XT2 ENDURO SERIES

Affected Model: 13A9A1CS010

Date: March 30, 2016

Subject: Possible Loose EFI Connector at the EFI Module (ECU)

Figure 1

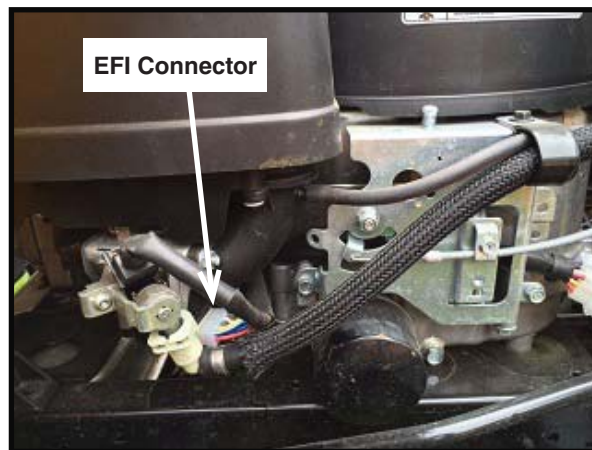
Purpose: A few of the main wiring harness connectors may have not been fully locked onto the ECU at the time of production on the above listed Affected Model, within the Affected S/N Range.

1. Inspect the EFI connector at the ECU, Figure 1, by gently tugging on the connector. If the connector remains attached to the ECU, no further action is required.
2. If the connector comes off, push it back onto the ECU until an audible click is heard, indicating that the locking tab on the connector is correctly seated onto the ECU. After clicked in, again gently tug on the connector to ensure a positive lock.
3. If a positive lock is not achieved, it may be necessary to secure the connector to the ECU with a zip-tie.
4. If using a zip-tie to secure the connector, be sure that the zip-tie does not pinch the wires at the connector.
